ADDENDUM

Project: **Crestwood School District
Crestwood High School
Field Building & Site Improvements**

Date: **March 27, 2023**

Addendum Number: **#2**

A3.00

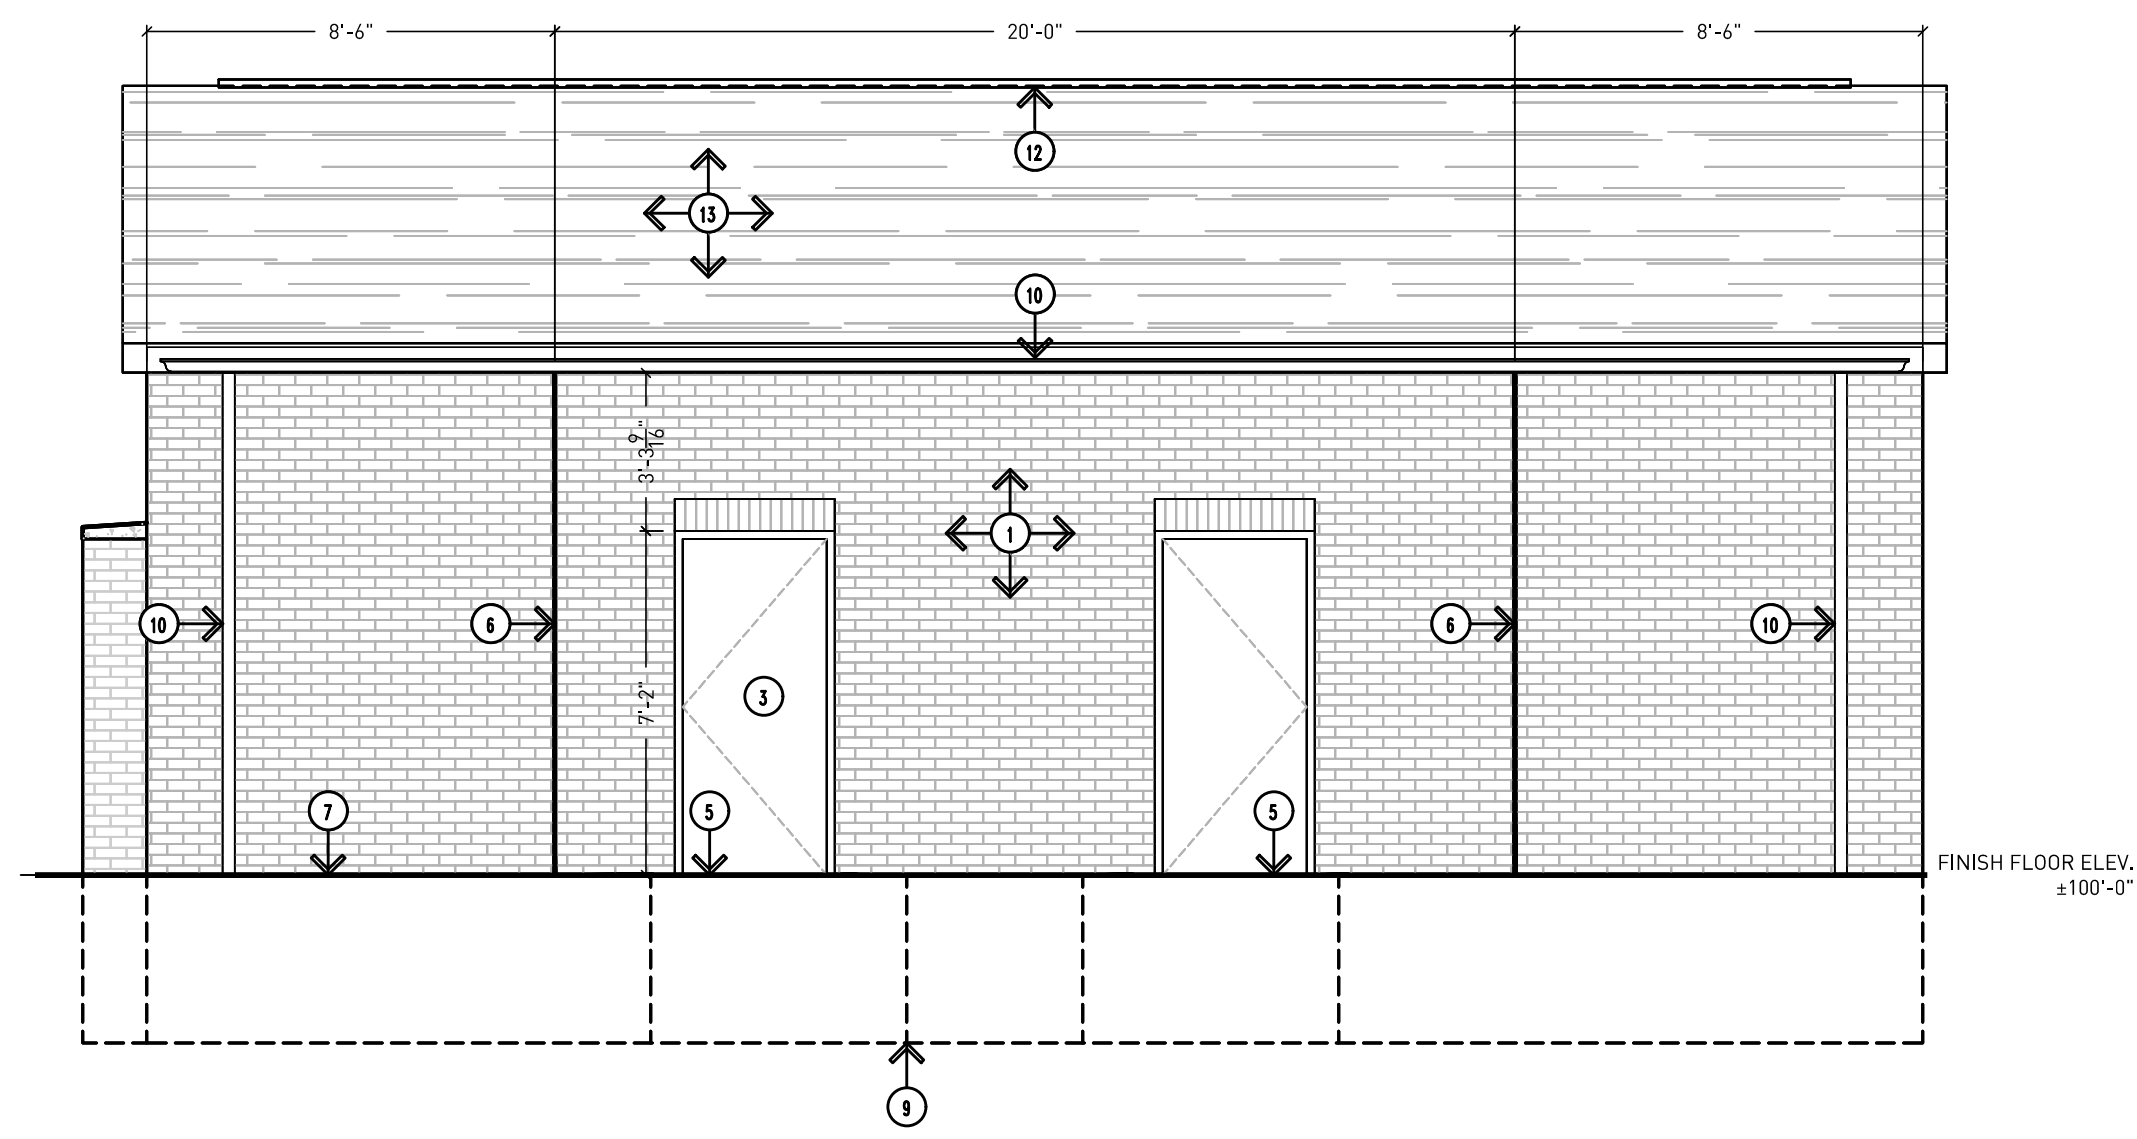
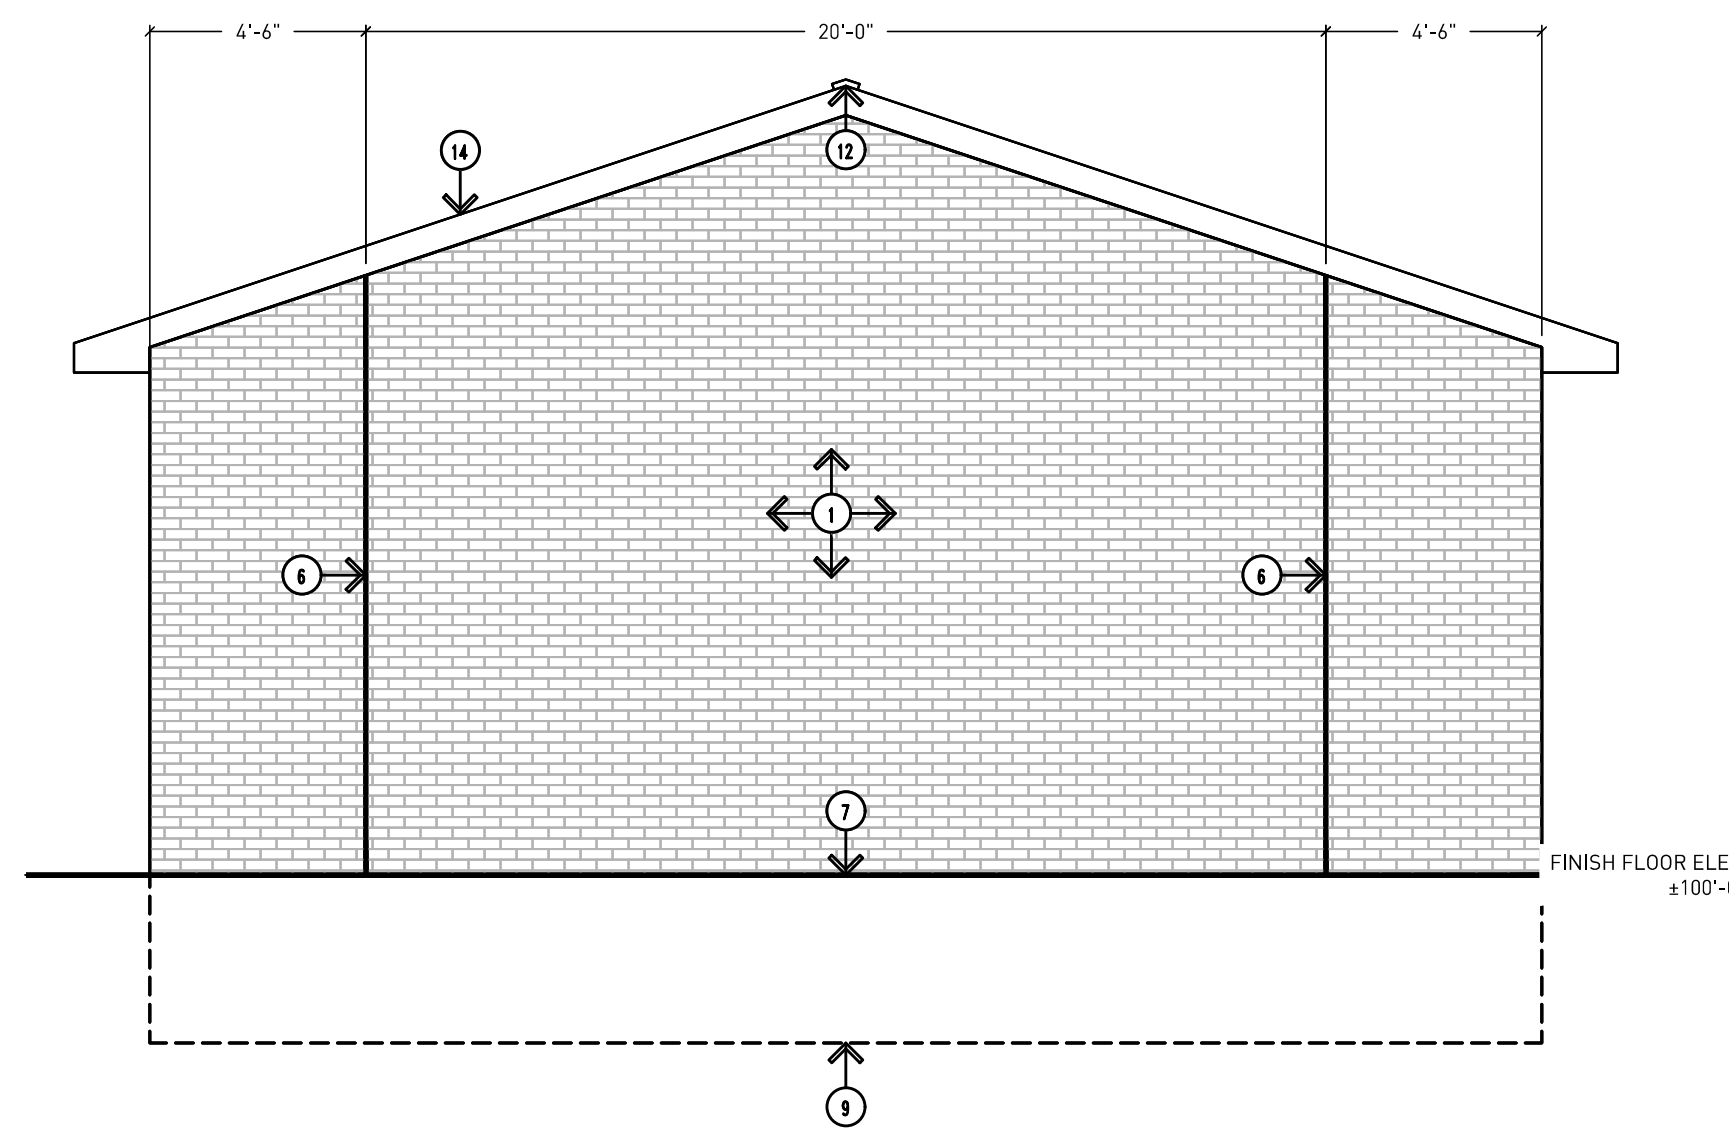
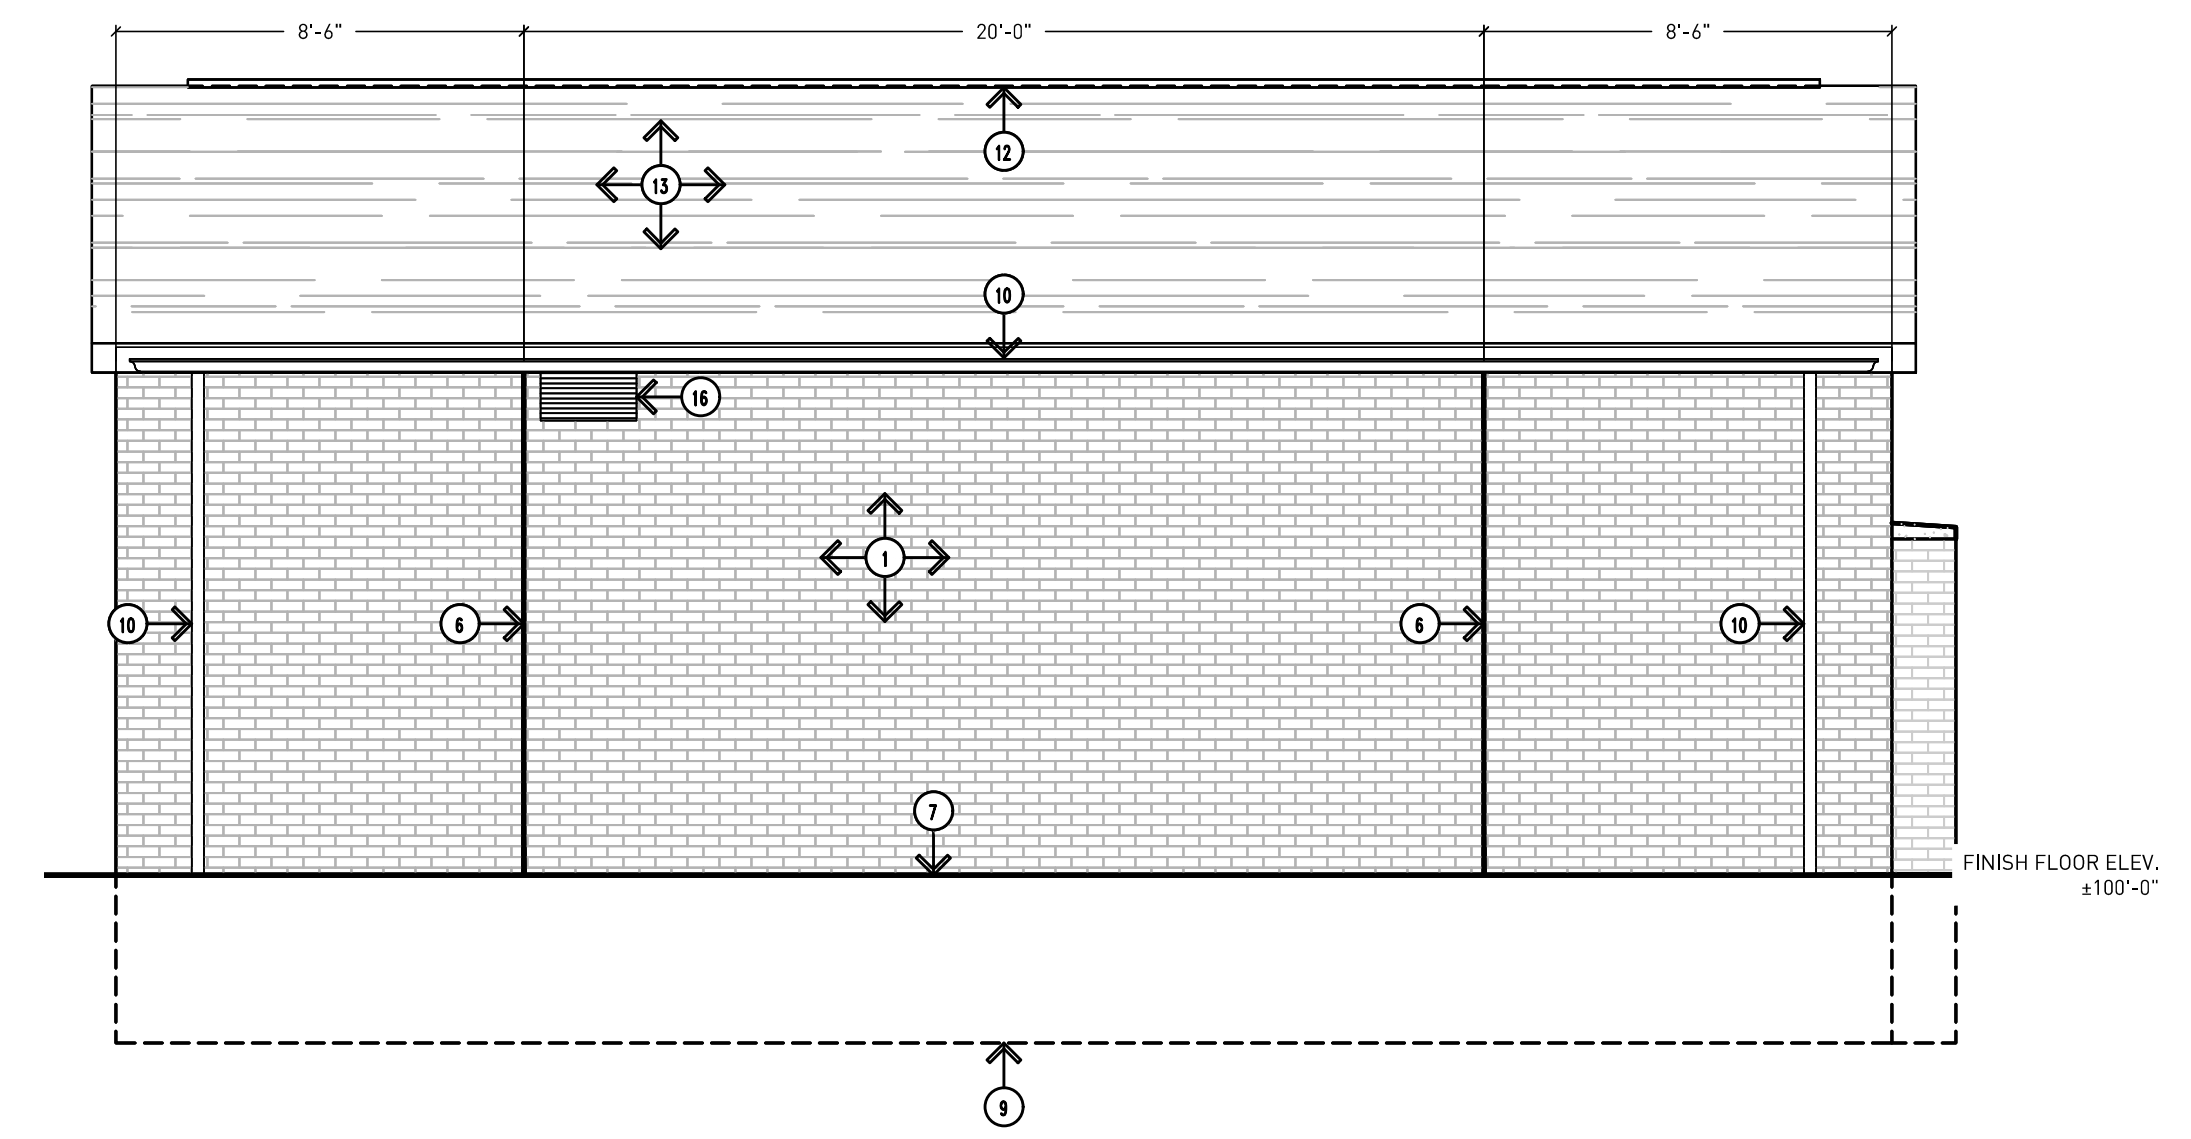
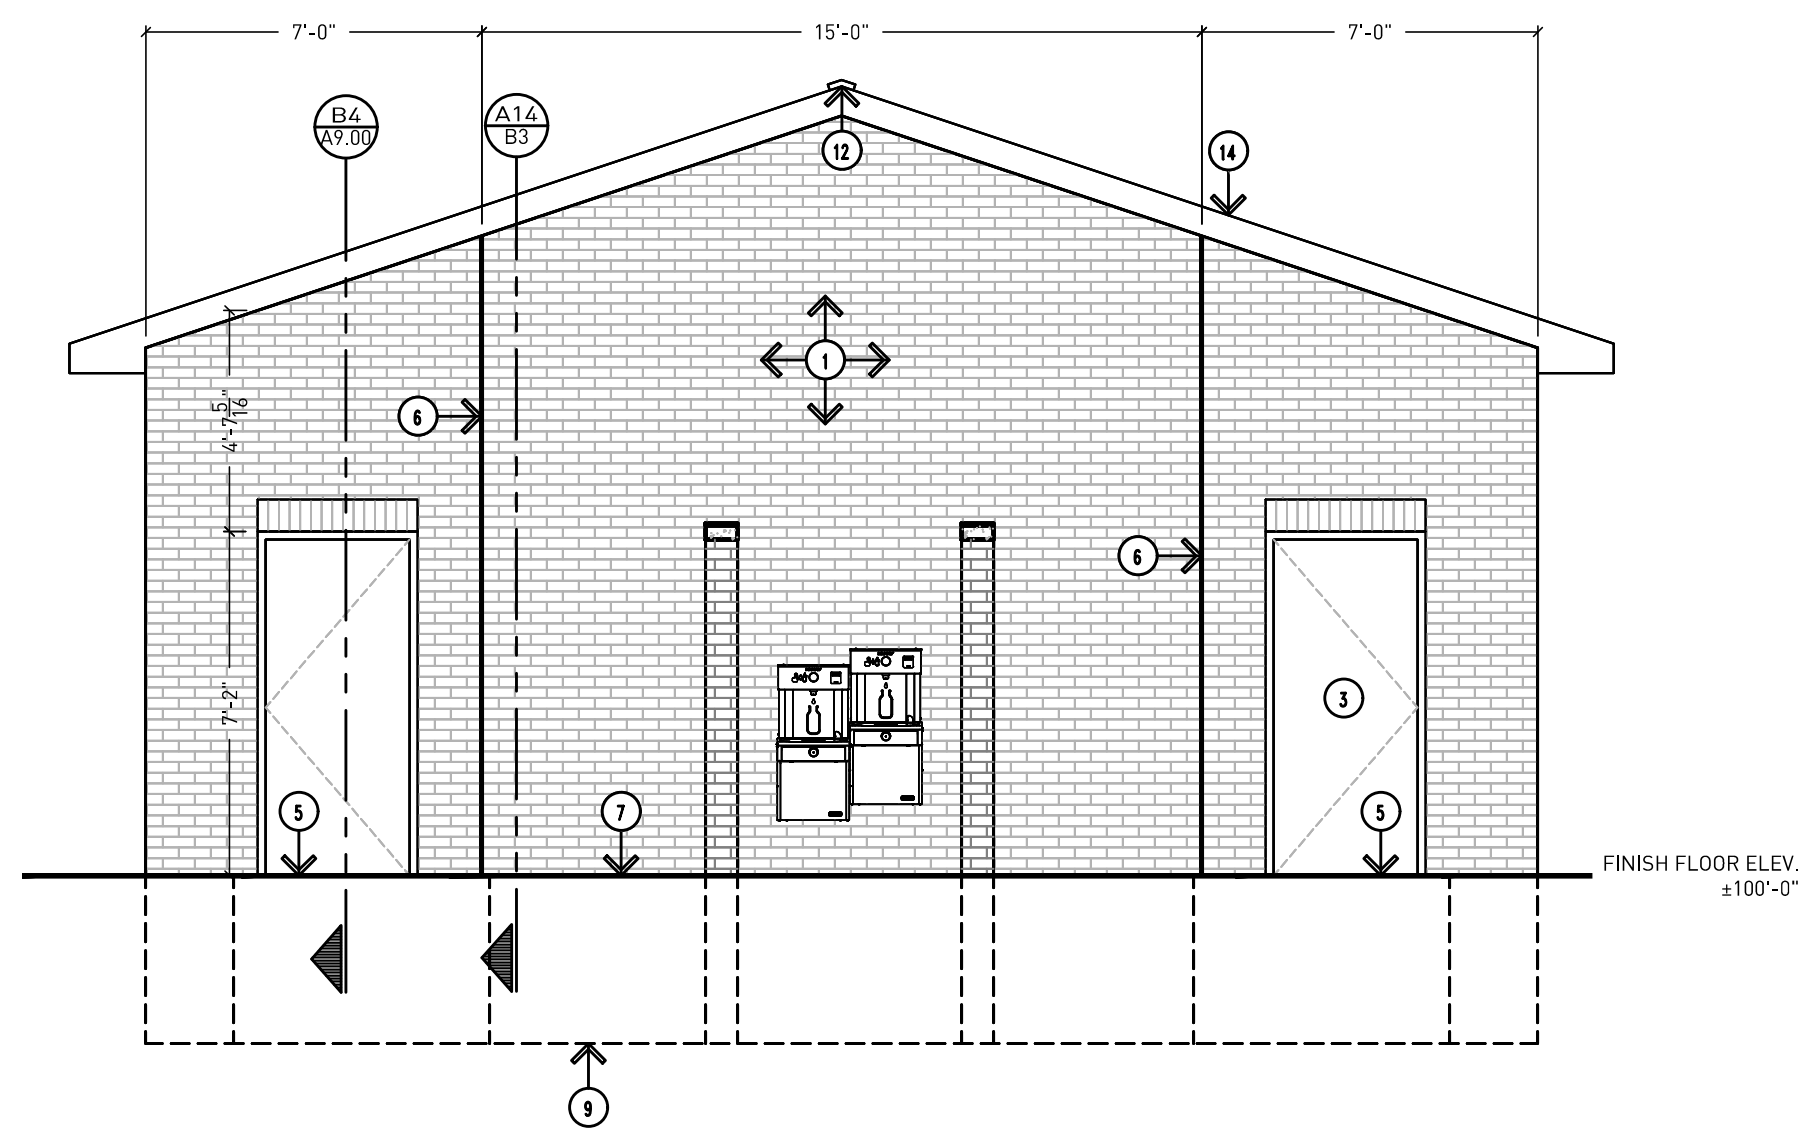
A3.00 – Exterior Elevations

CHANGE:

- FROM:** 4" brick veneer to match existing (install header course every 6 rows of brick). — color to Belden Brick "1-HB".
- TO:** 4" brick veneer to match existing (install header course every 6 rows of brick). — color to Belden Brick "Sandford".
